EI027-DMF-VD-QC-PRO-023-R01

**NDT TABLE**

WELD MAP

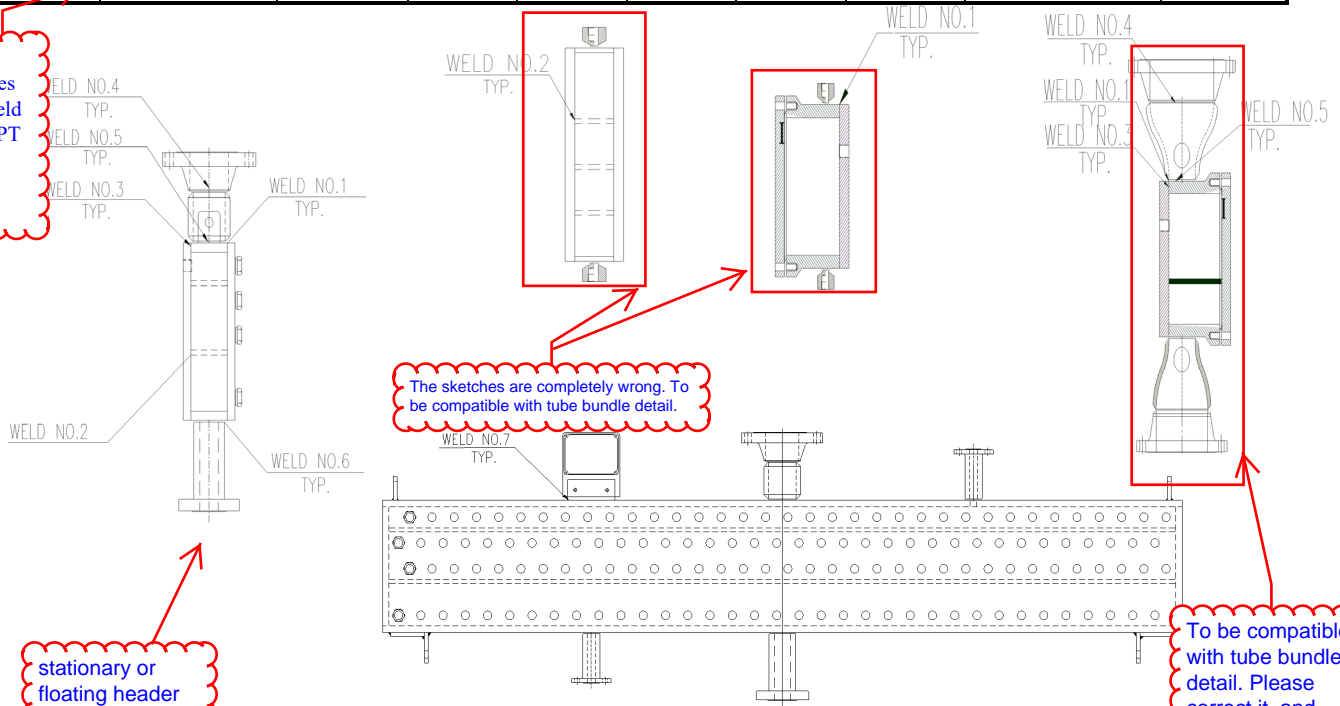
-Please add a column for description.  
 -Please add columns for mention the material of the two pieces which are joined to each other.  
 -Please follow the attach sample for NDT before PWHT (RT,UT & PT).  
 -Please add tube to tube sheet joint.  
**(Attach file can be a sample. please use it and ignore the columns and rows which have been crossed)**

Partition plate to tube sheet and plug sheet (weld No.2) to be 100% UT

Name plate bracket and other accessories to header boxes (weld NO.7) to be 100% PT before PWHT

Please add a sketch for tube to tube sheet joint.

TOP & BOTTOM PLATE TO TUBE SHEET & PLUG SHEET

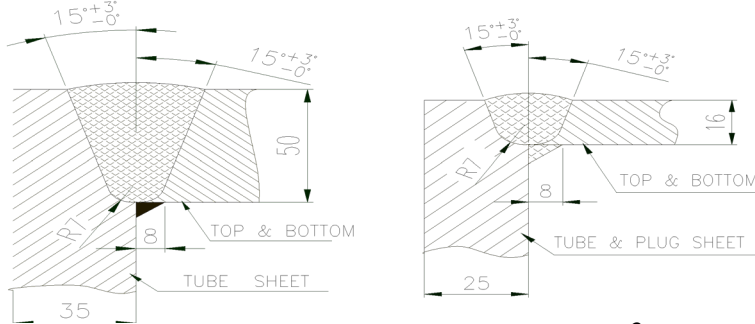
The sketches are completely wrong. To be compatible with tube bundle detail.

stationary or floating header to be specified

To be compatible with tube bundle detail. Please correct it. and specify the header (stationary or floating)

Weld maps are not compatible with tube bundle detail. please check all of them.
